**Optimization Review**  
**Fairfield Coal Gasification Plant Superfund Site**  
**Fairfield, Iowa**

Report of the Optimization Review  
Site Visit Conducted at the Fairfield Coal Gasification Plant Superfund Site on  
February 14, 2012

Final Report  
July 30, 2012

**FIGURE 1**  
**General Site Map**

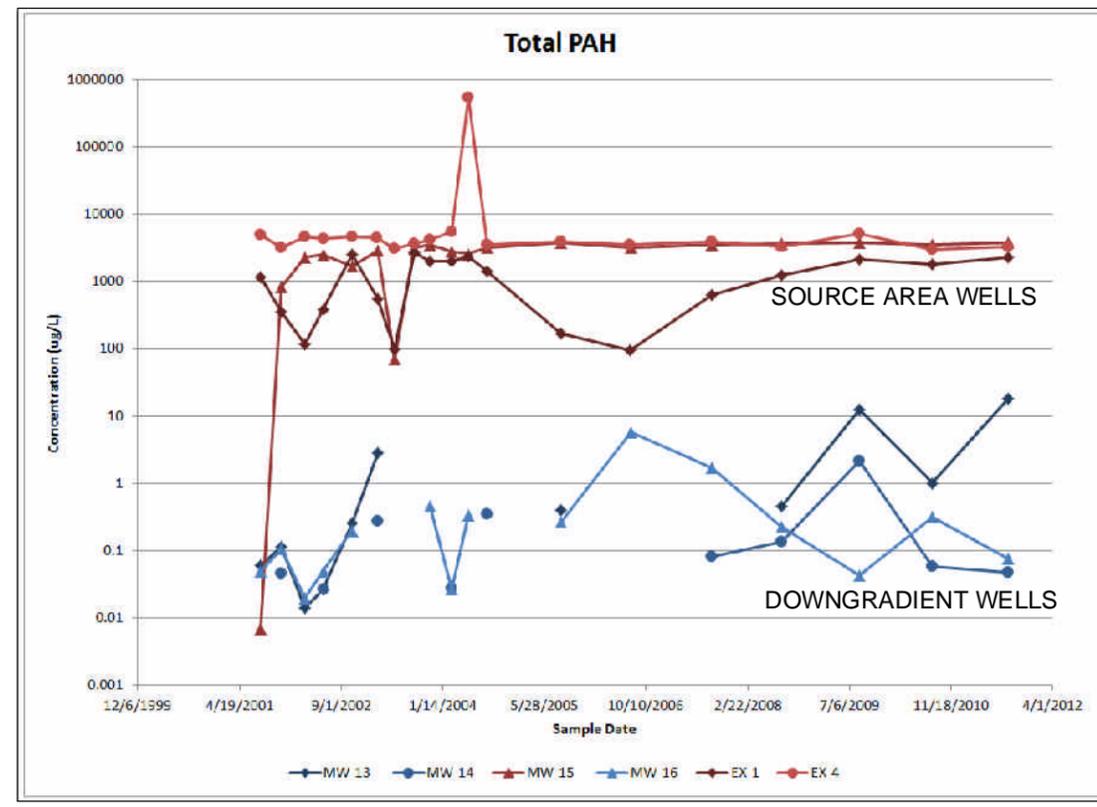
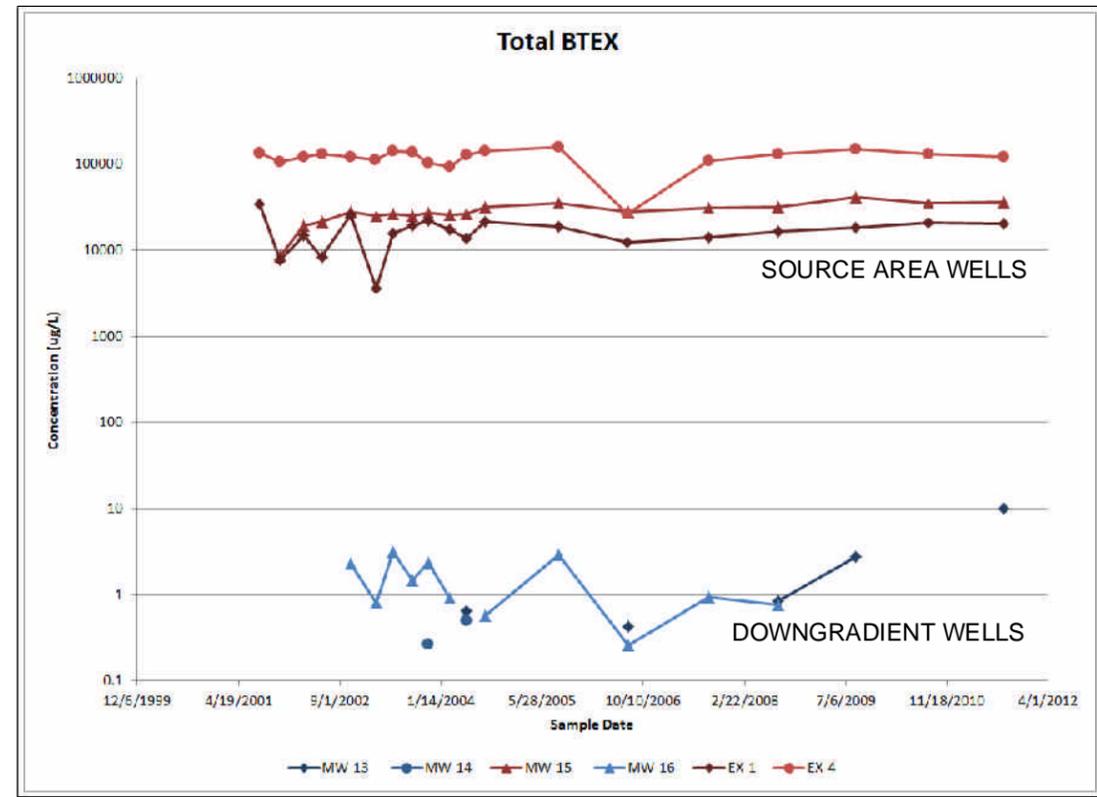
**Technical improvement** – The optimization review team recommends adding an aerial photo to the existing figures to help orientate the reader to the site and providing trend charts for key monitoring wells instead of the data tables on the maps. The cost for implementing this recommendation is negligible.
